MEMORANDUM

Subject: **Transfer 70627, Bybee**

SOUTHERN IDAHO TRUST- NON TRUST AREA

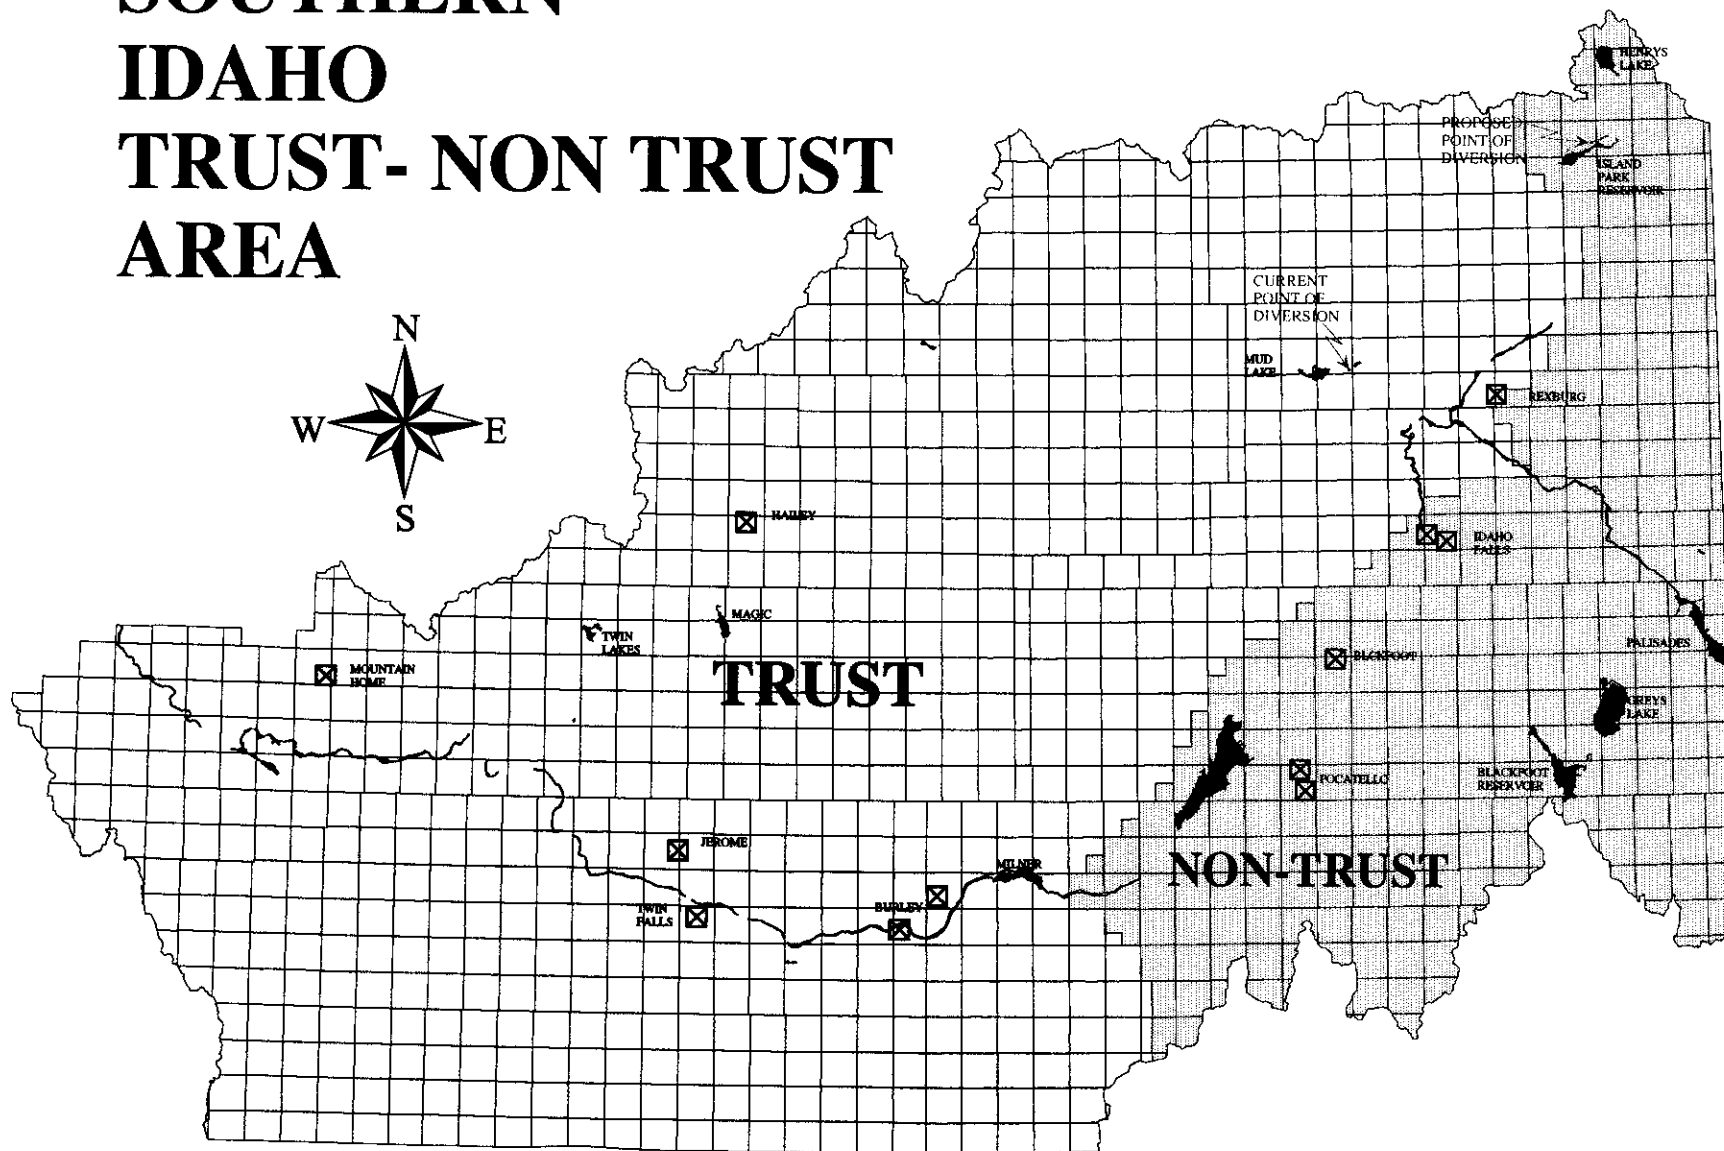
It is my understanding this transfer involves moving one ground water right to two different areas. One is within the ESPA model boundary and the other is outside the ESPA model boundary. Questions have only been asked about the transfer outside the ESPA boundary which involves transferring 13 acre-feet from T07N, R35E sec 36 (near Mud Lake) to T13N, R42E sec 24 (near Island Park Reservoir) for use in a pond (see Attachment). The following is a brief hydrologic review concerning only that portion of the transfer.

The transfer also involves moving from a trust to a non-trust area. Flow at Milner will be reduced by approximately 13 acre-feet per year.
